## **AMENDMENT TO THE DRAWINGS**

# Annotated Sheet Showing Changes

FIG. 8

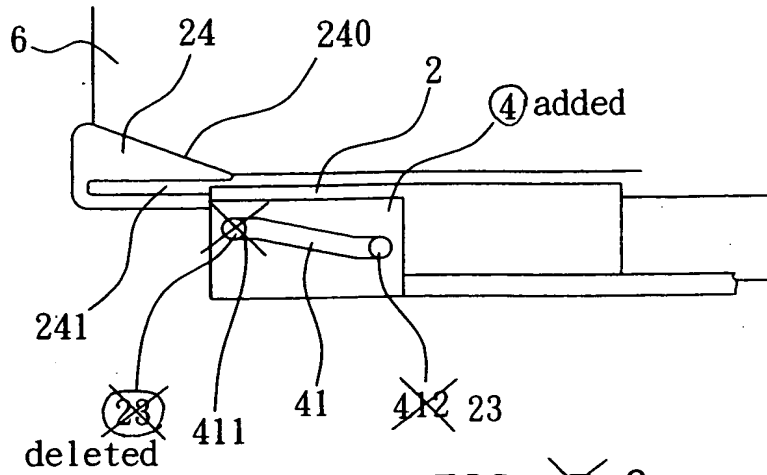
The original Fig. 7 is changed into Fig. 8, and the original Fig. 8 is changed into Fig. 7.

In the new figure 8, the guiding wedge 23 moves along the cam groove 41 and pushes the lower panel 4 upward until the guiding wedge 23 is located at a low point of the cam groove 41, and the lower panel 4 is higher than the upper edge of the cutter 5.

FIG. 7

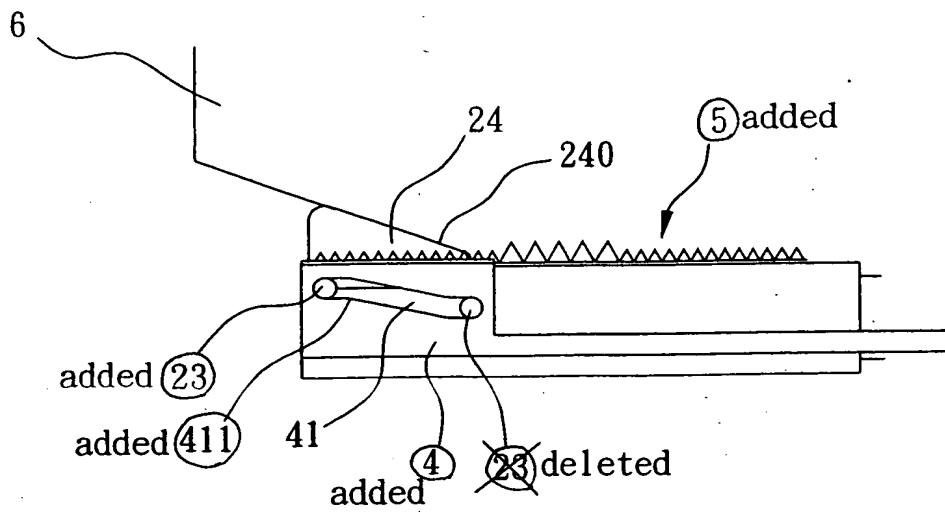
In the new figure 7, the guiding wedge 23 is located at a high point 411 of the cam groove 41, and the lower panel 4 is lower than the upper edge of the cutter 5 to expose the upper edge of the cutter 5.
